MEETING AGENDA

CITY OF BEAUFORT - HISTORIC DISTRICT REVIEW BOARD

Wednesday, June 10, 2026, 2:00 P.M.

EXTERIOR
WEST BUILDING
ELEVATIONS
PROGRESSION

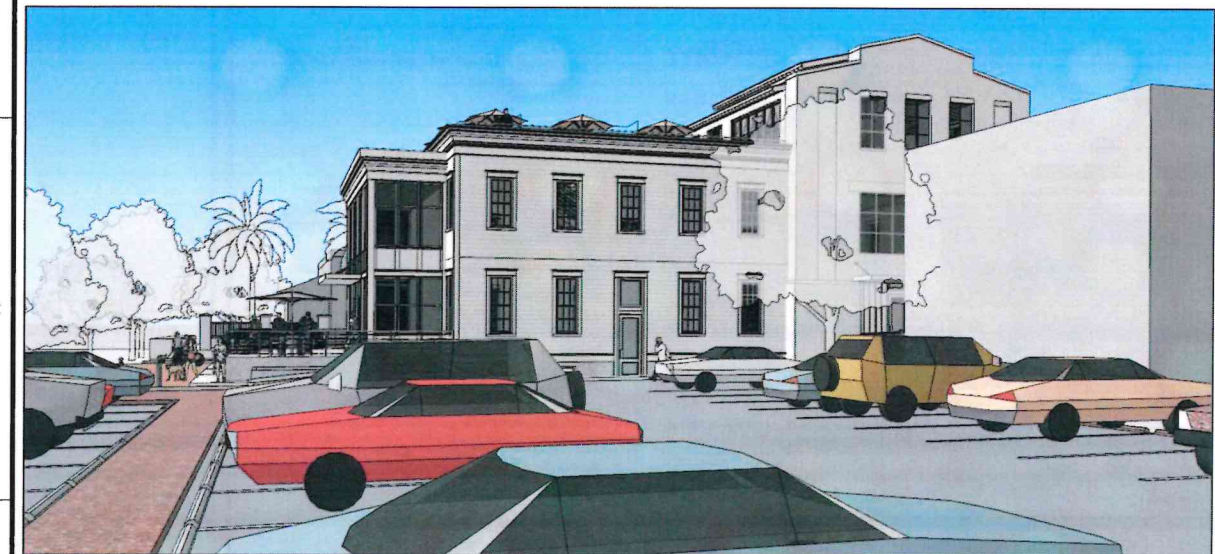
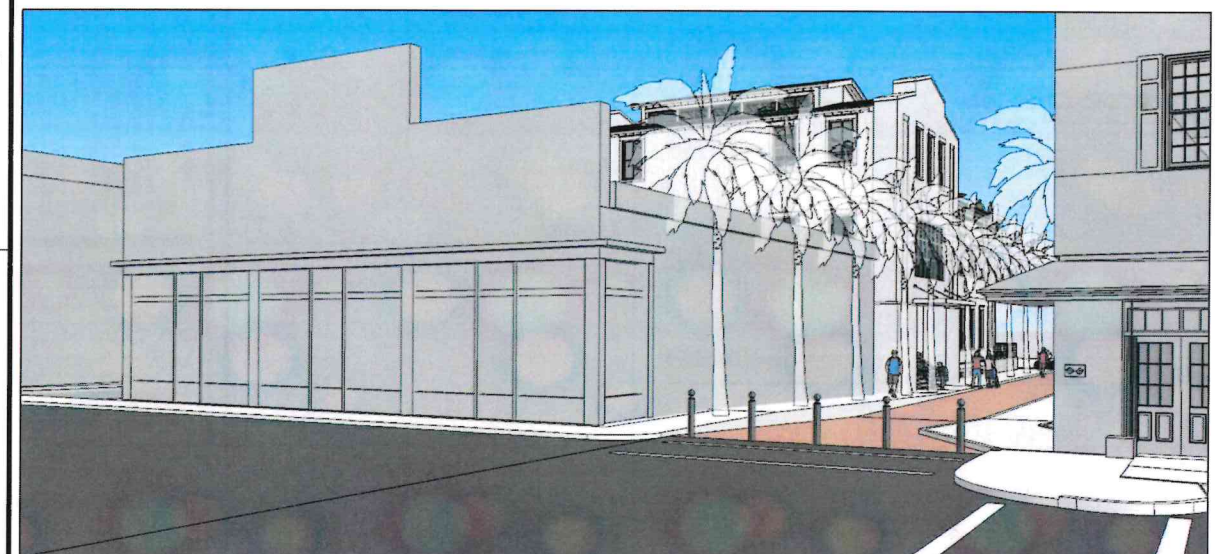
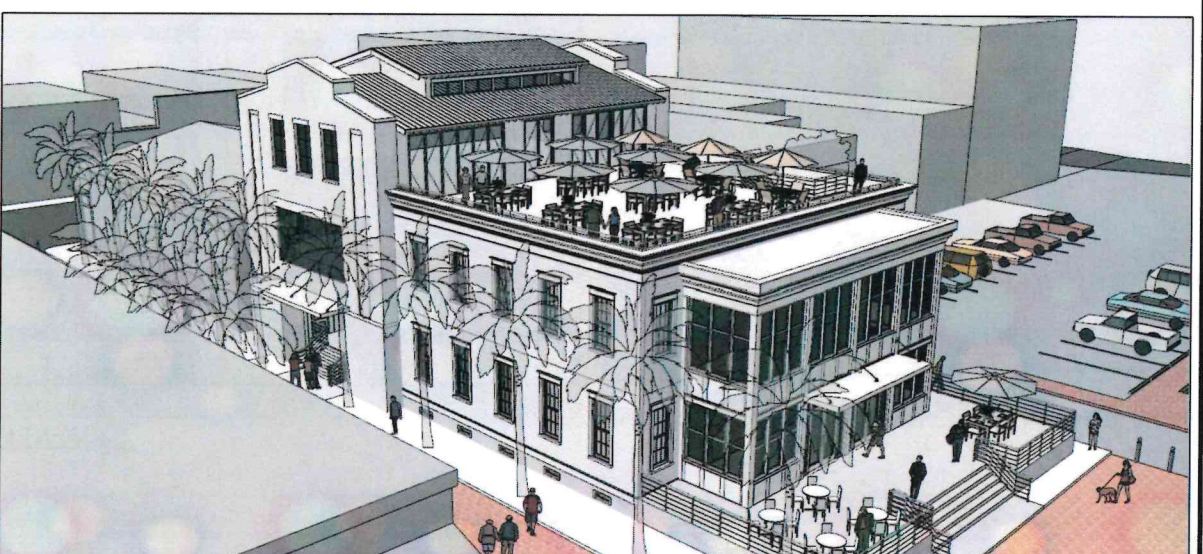
7. Applicant to provide typical sections and details at final review.
8. Applicant to provide a cutsheet for any railings.
9. Restudy the height and scale of the center building, as its current height is felt to be too tall compared to surrounding structures.
10. Consider alternative materials to Efis.

The height of the central raised gable portion of the parapet walls (east and west elevations) has been reduced by 1’-6”. Sheets A-201 (elevations) and A-202 (3-Dimensional Model Views) have been revised to reflect this change. In addition, Sheet A-201.1 has been added to the set for comparison. Please see the following page for images.

A height comparison diagram with the surrounding structures is provided on sheet A-201. This diagram has been updated to reflect the decrease in height.

OLYMPUS
Horizontal Bar Railing

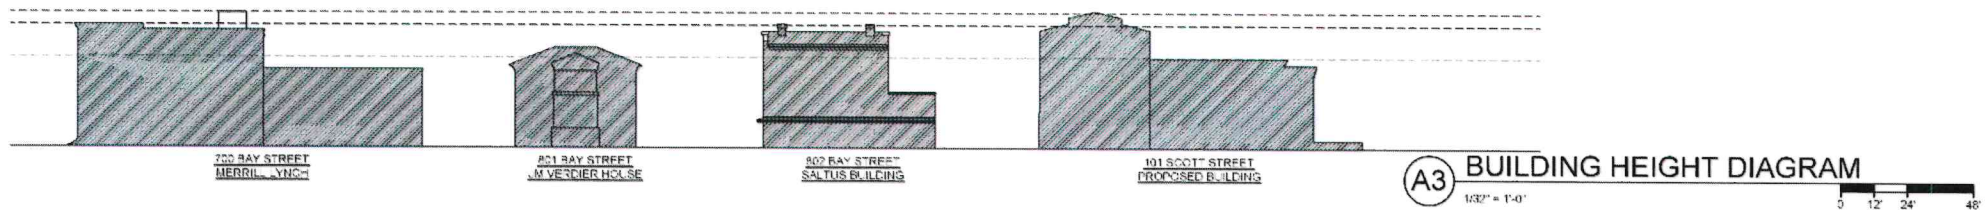
8. “Applicant to provide a cutsheet for any railings.”

A cutsheet for the railings has been provided on sheet G-105.2 and is also provided below

3) Guest House (ADU) – with optional access ramp shown (as revised):

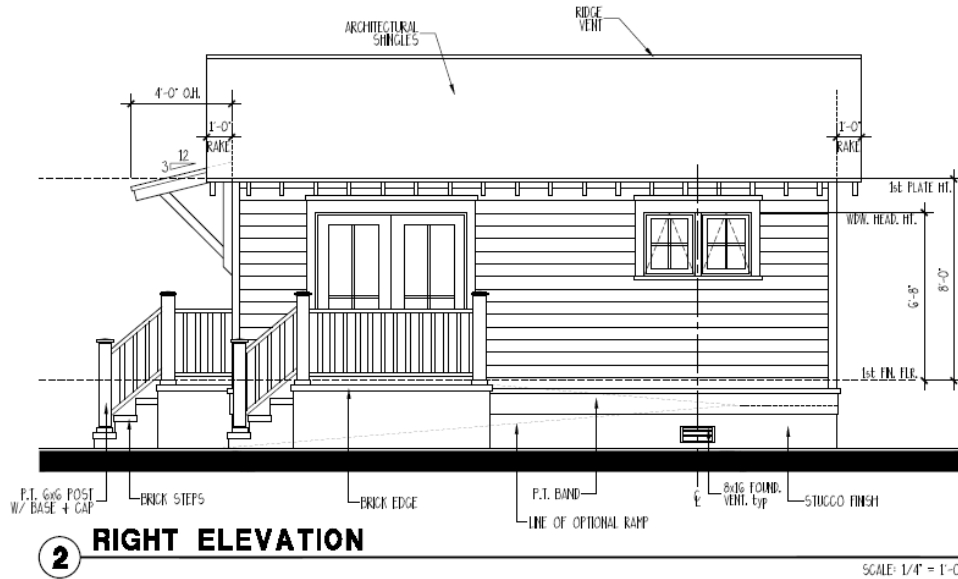
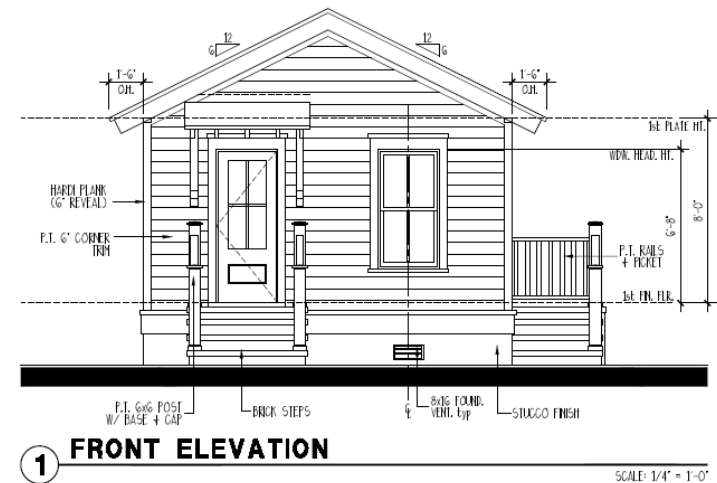
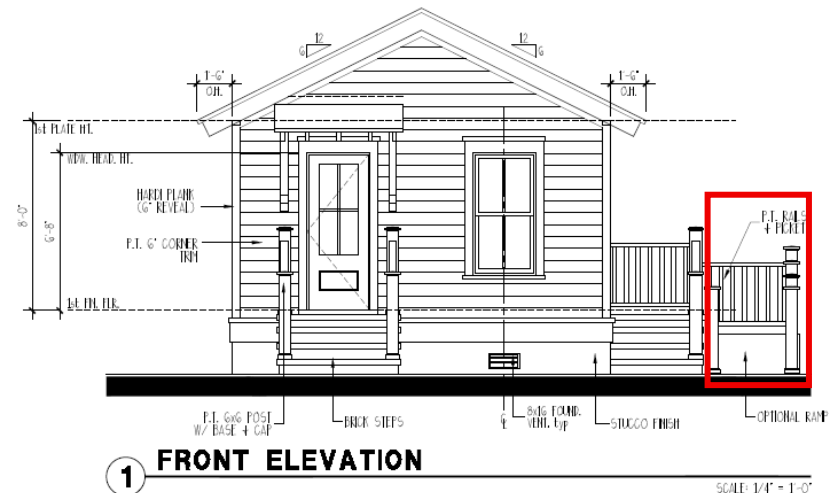
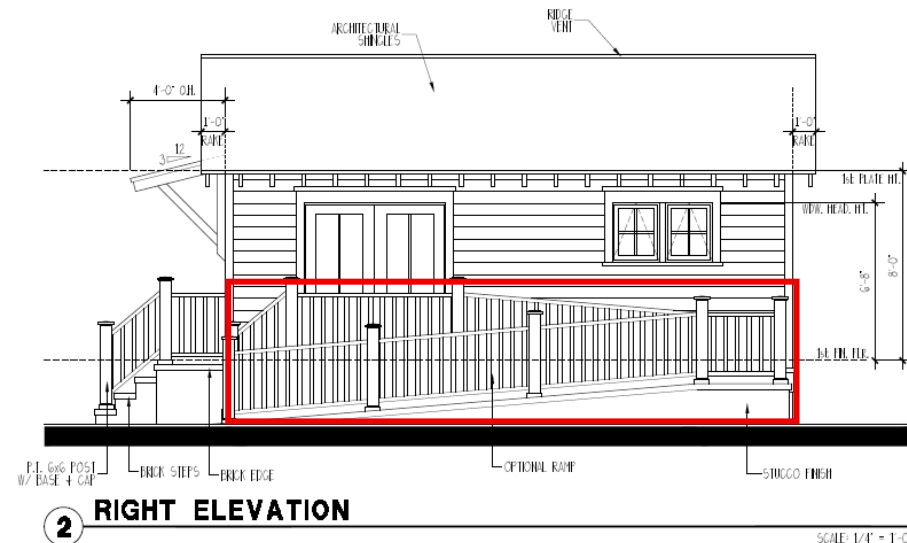
2. At the first HTRC meeting, staff recommended the applicant consider adding dormers to add a small "half-story" space, while still lowering the overall ridge height to be complementary to the main house. The ridge height of the ADU would need to be lowered by approx. 5' to at least equal the height of the main house. The use of dormers and lowering of the ridge would not allow for all of the program that the applicant is trying to fit on the second floor.

Roofed building footprint: 394 sq. ft.; Heated living space: 384 sq. ft.; Size of front porch: 10 sq. ft. roofed; Area of front steps: 13 sq. ft. uncovered; Other: 42 sq. ft. semi-covered side stairs/ADA-accessible ramp)
